BECK AGRICULTURAL CENTER PARKING LOT PAVING-2010

PROJECT ID: 109657
(CONSTRUCTION PLANS)
TIPPECANOE COUNTY

REVISIONS		
SHEET NO.	DATE	ITEM
C103, C104, C105	5/26/2010	REVISED SOUTH ROAD 24' WIDE

SITE LAYOUT PLAN

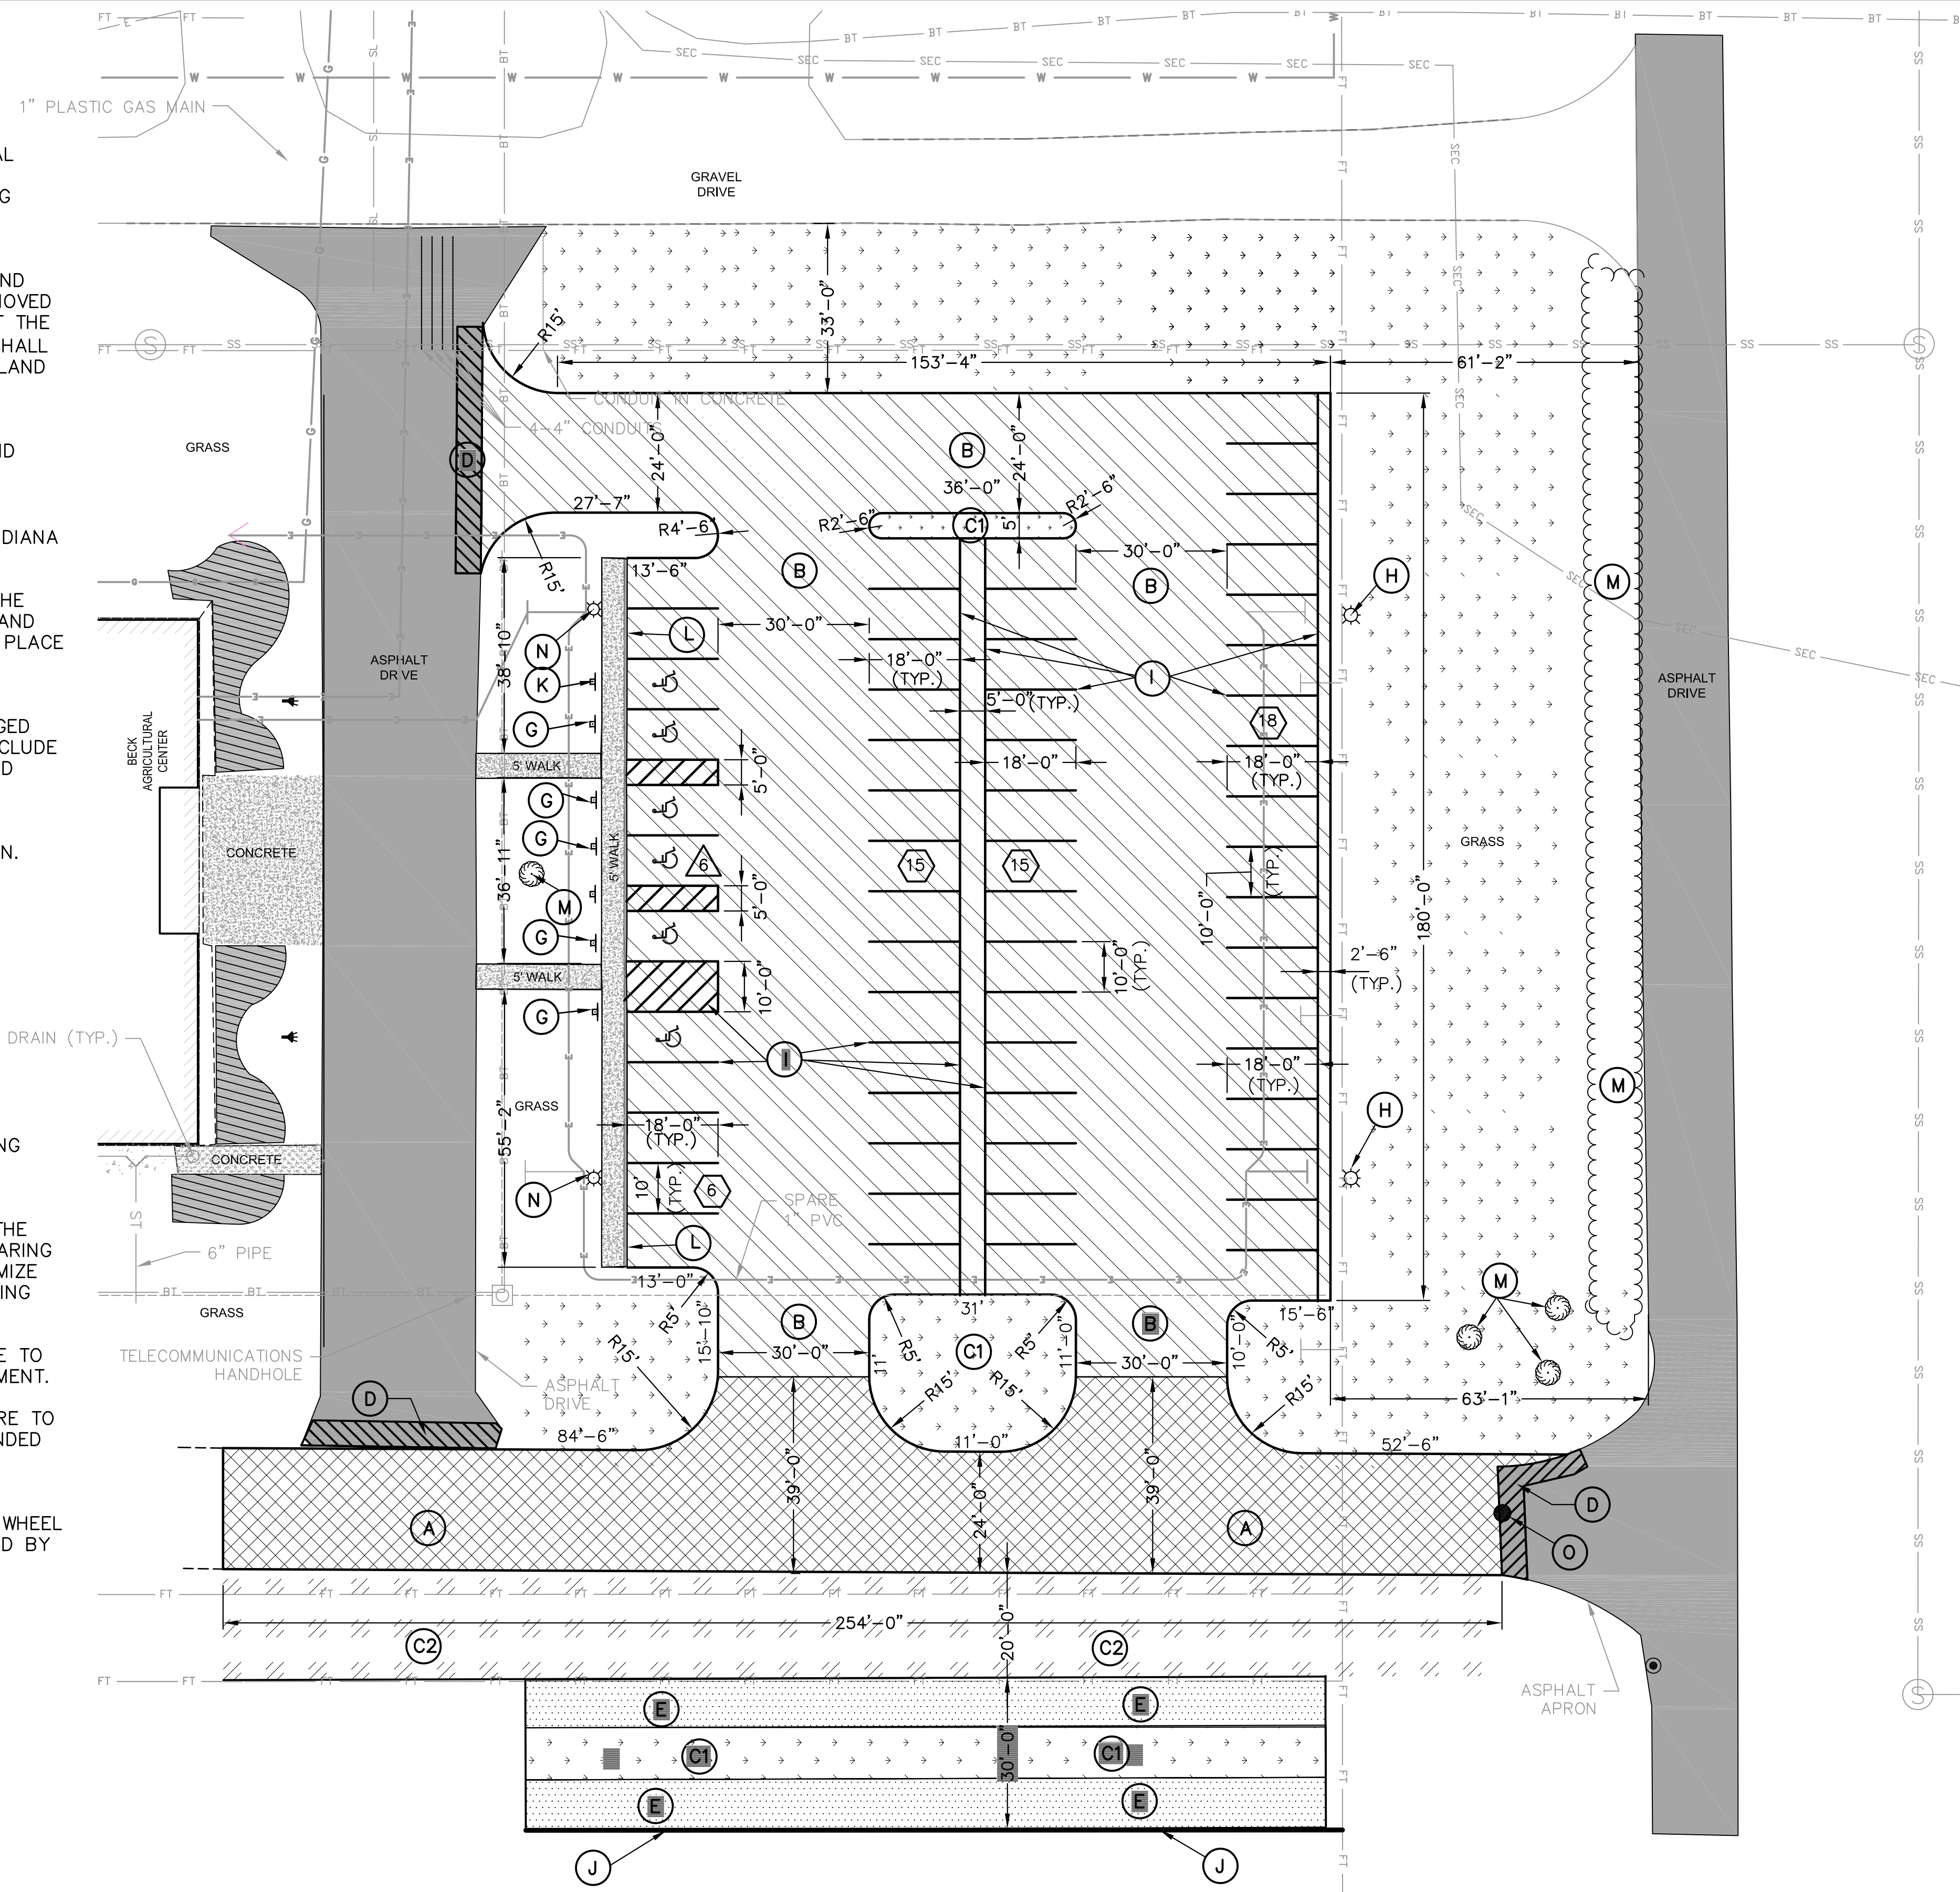
REVISIONS	
DATE	ITEM
5/26/2010	REVISED HEAVY DUTY HMA ASPHALT LIMITS

GRADING PLAN

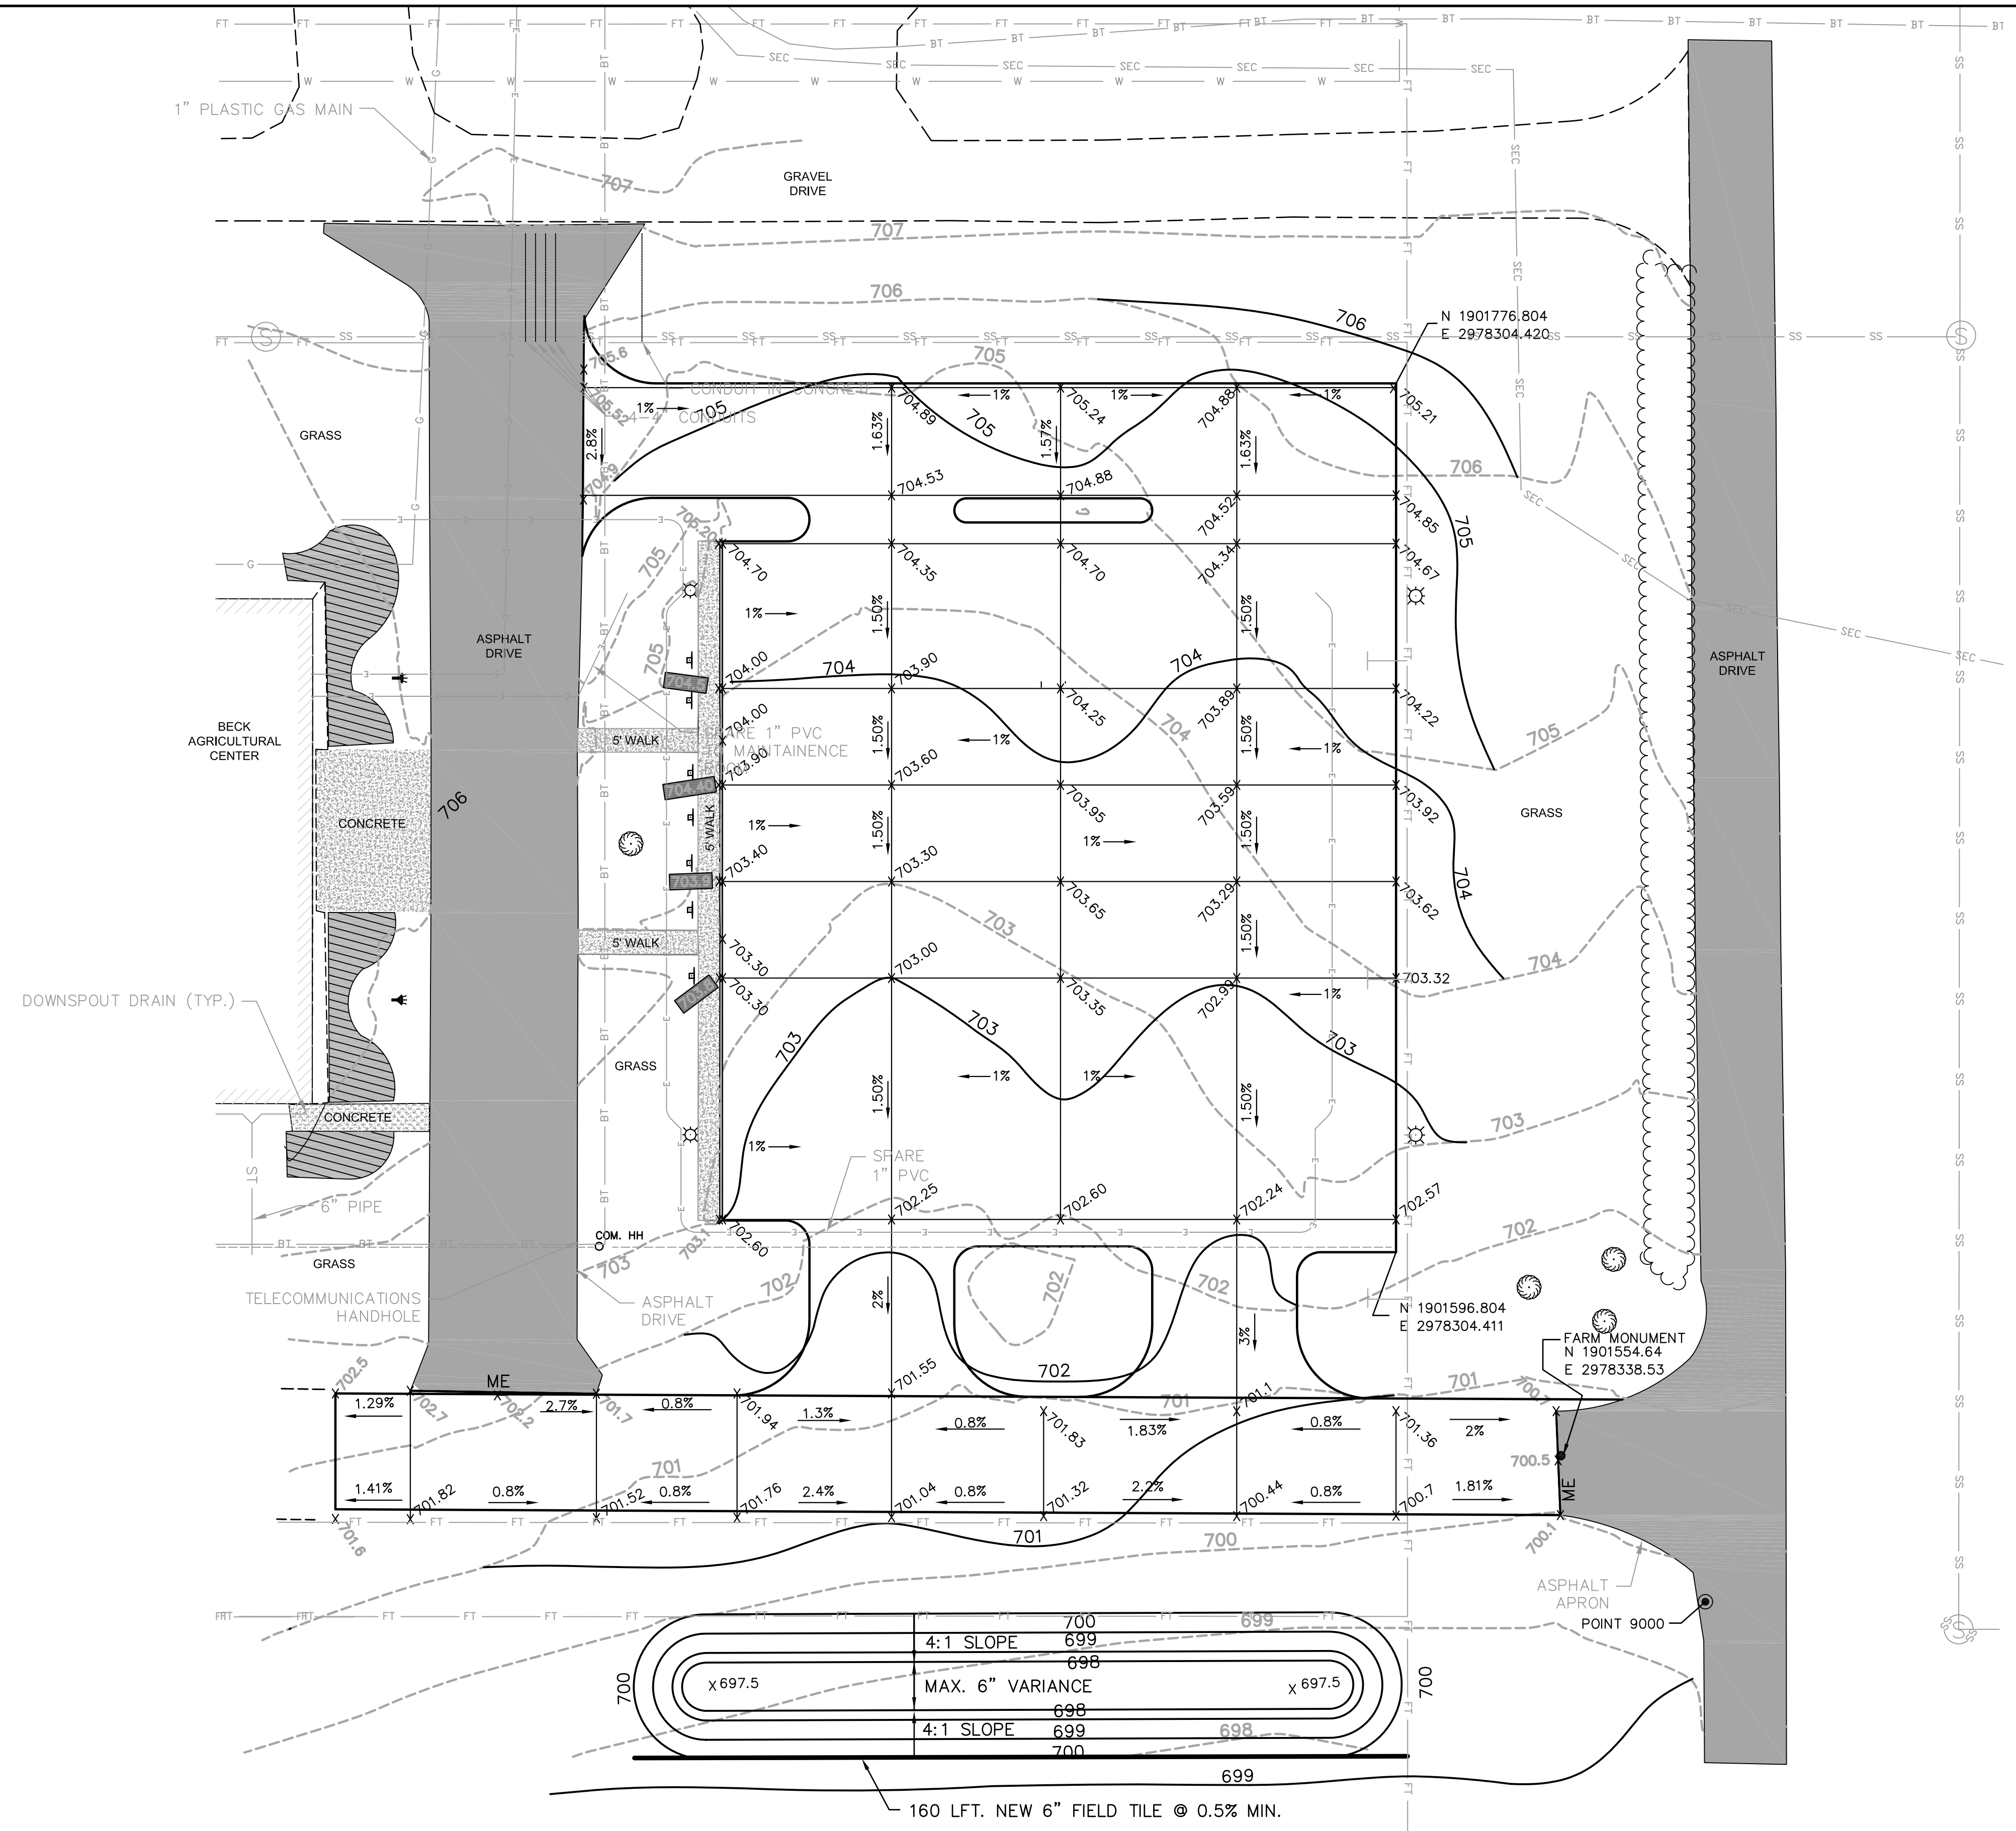
REVISIONS	
DATE	ITEM
5/26/2010	REVISED TILE NOTATION

**STORMWATER POLLUTION
 PREVENTION PLAN**

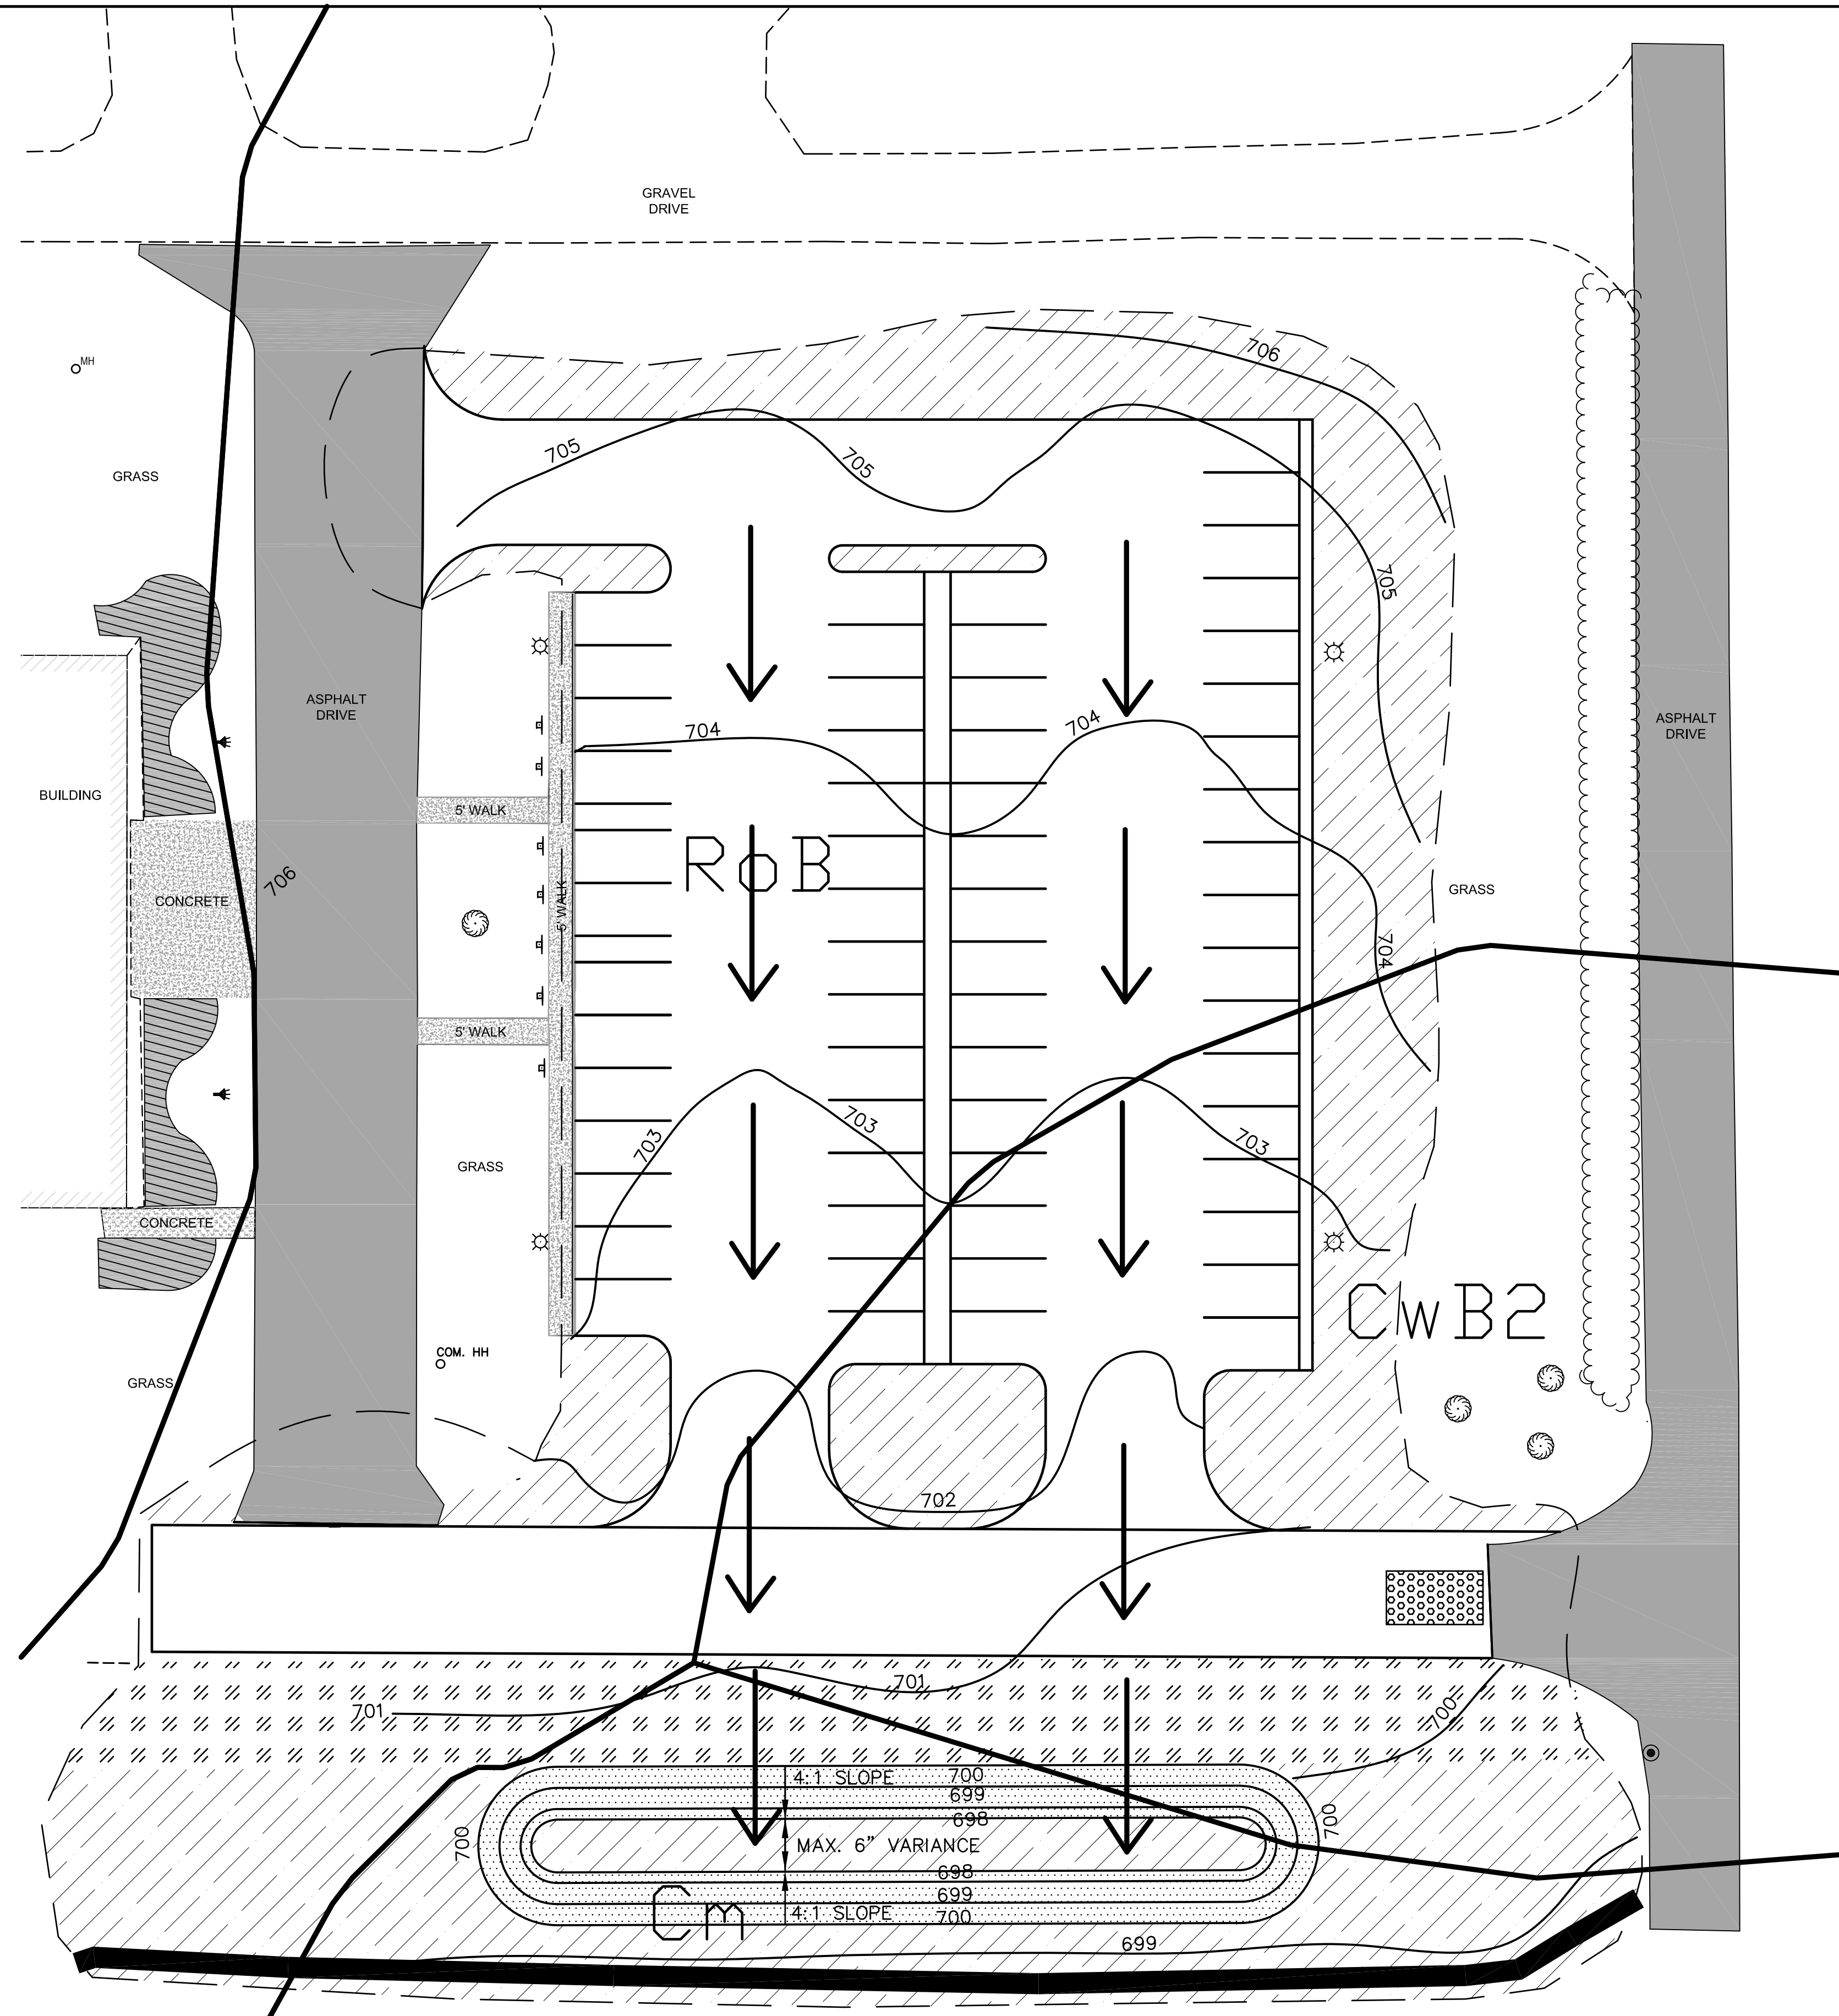
REVISIONS	
DATE	ITEM
	REVISED SOUTH ROAD 24' WIDE
